ADMINISTRATIVE AMENDMENT (FPA) ADD2015-00209

**ADMINISTRATIVE AMENDMENT
LEE COUNTY, FLORIDA**

Attachment “A” – Final Plan Approval - Site Plan

RE: *Miromar Lakes*
 Tract N-N, Positano
 Final Plan Approval
 HM Project No. 2014.099

SITE PLAN

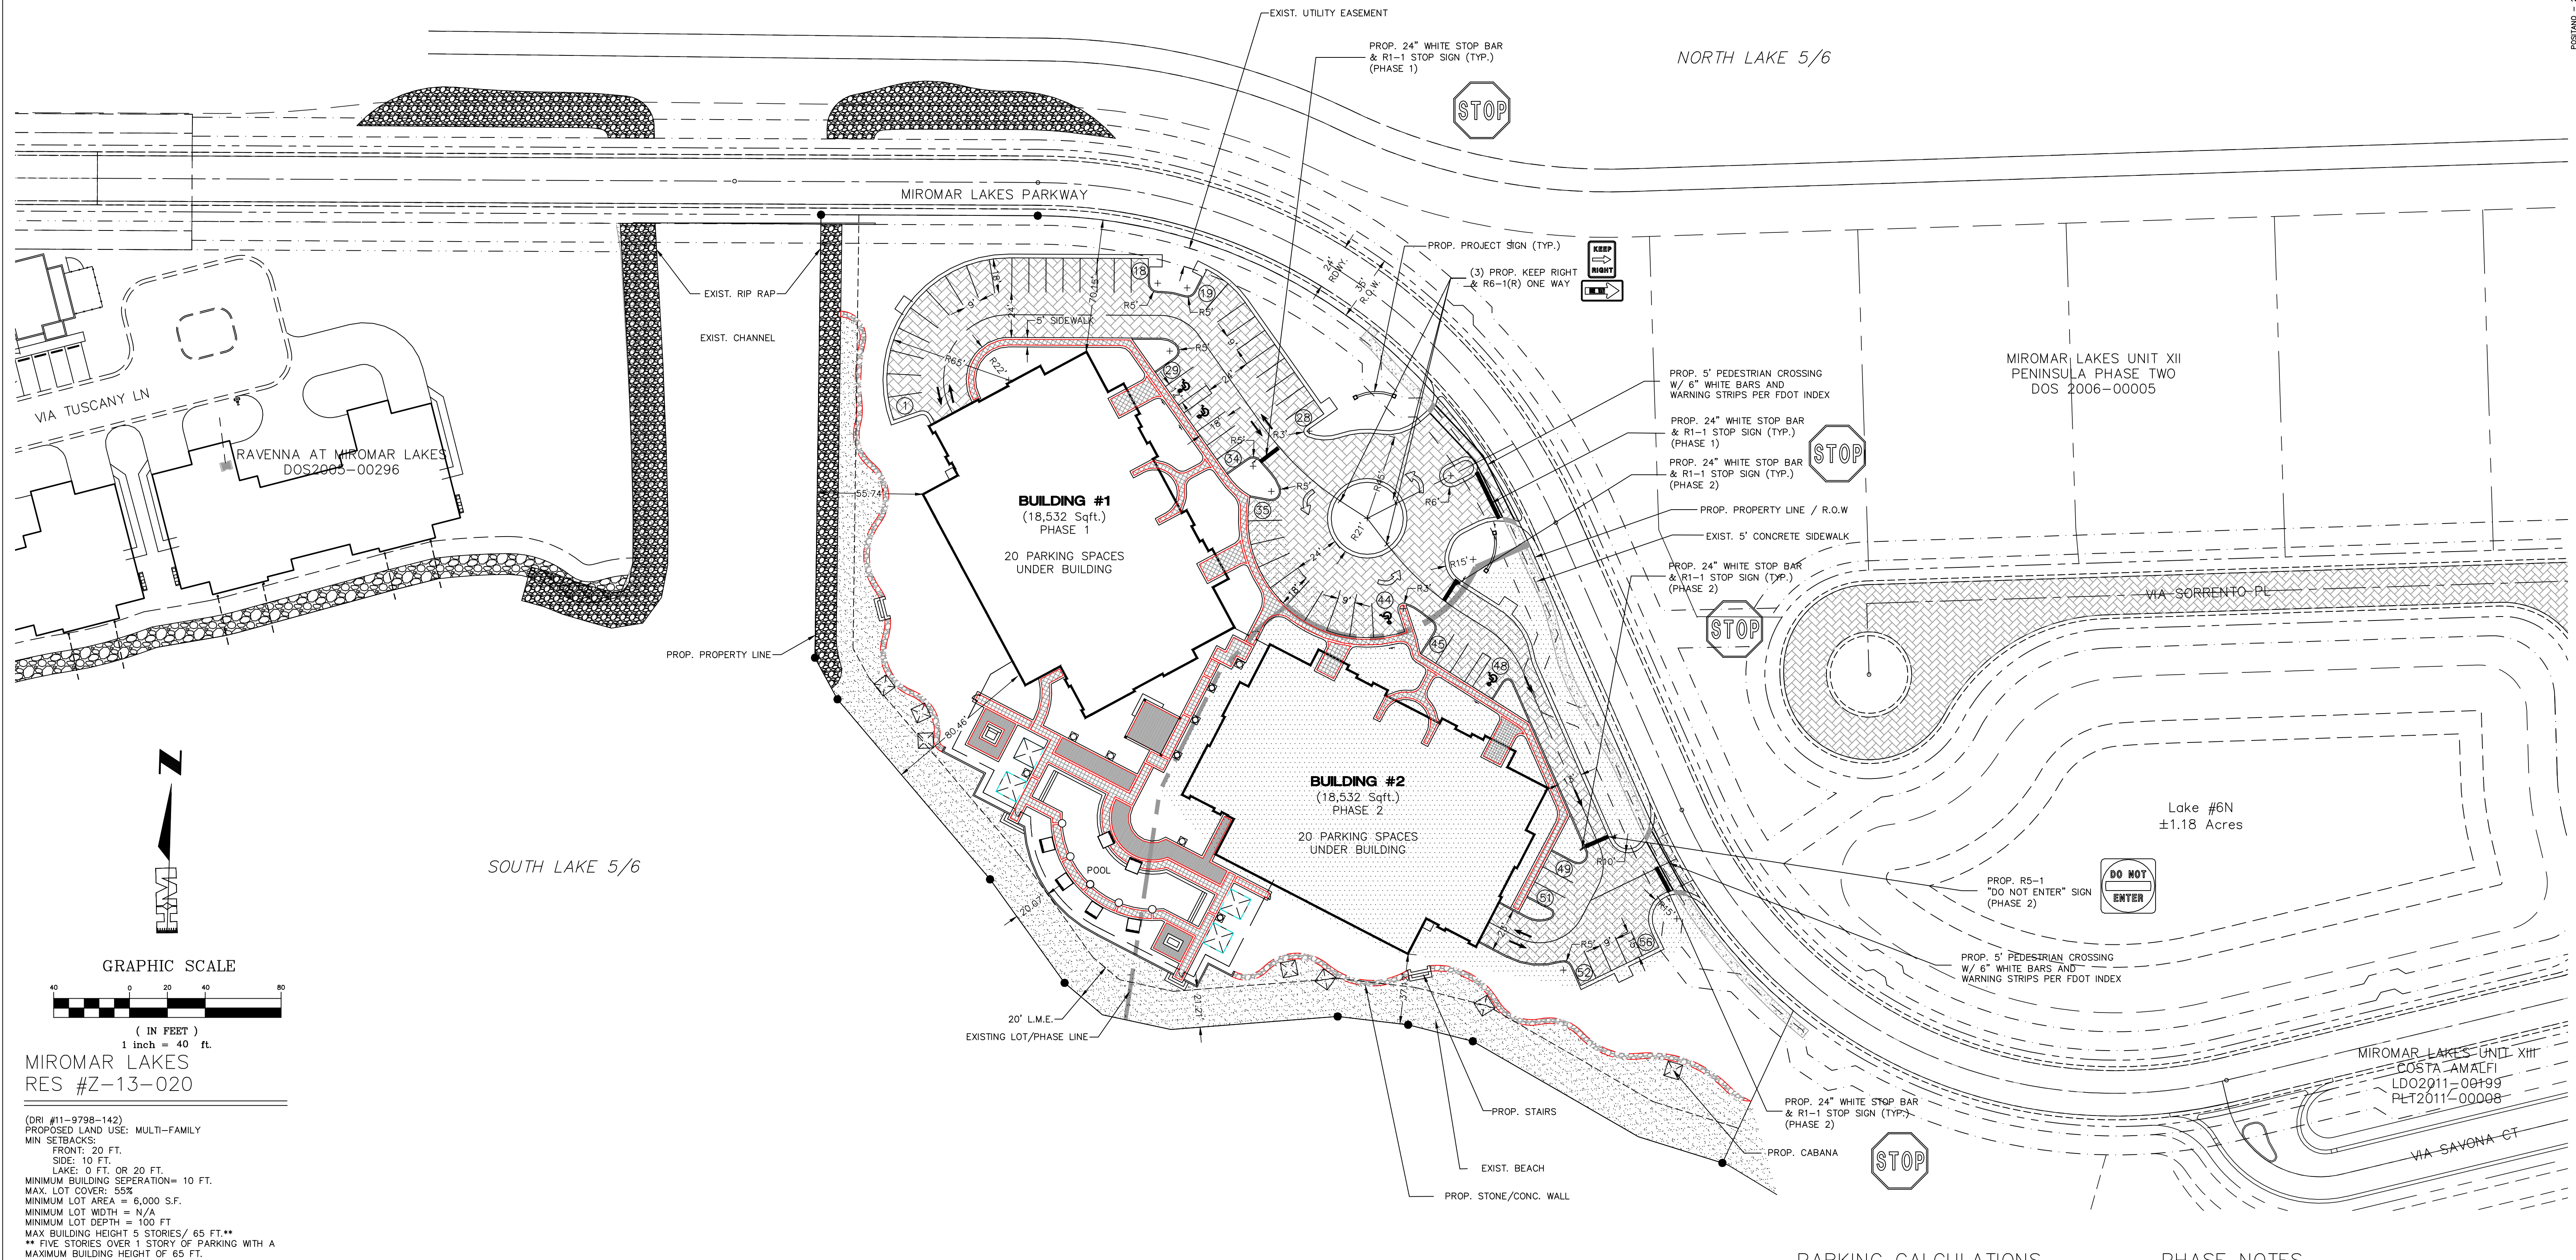
1. **The Development must be in substantial compliance with the Final Plan Approval: Site Plan per Attachment "A".**
2. **Any development which is not consistent with the final site plan approved herein and attached hereto, will require an additional, amended final plan approval.**

DEVIATION (7): Brick Pavers to Replace 1 1/2" S-1 on Private Roads
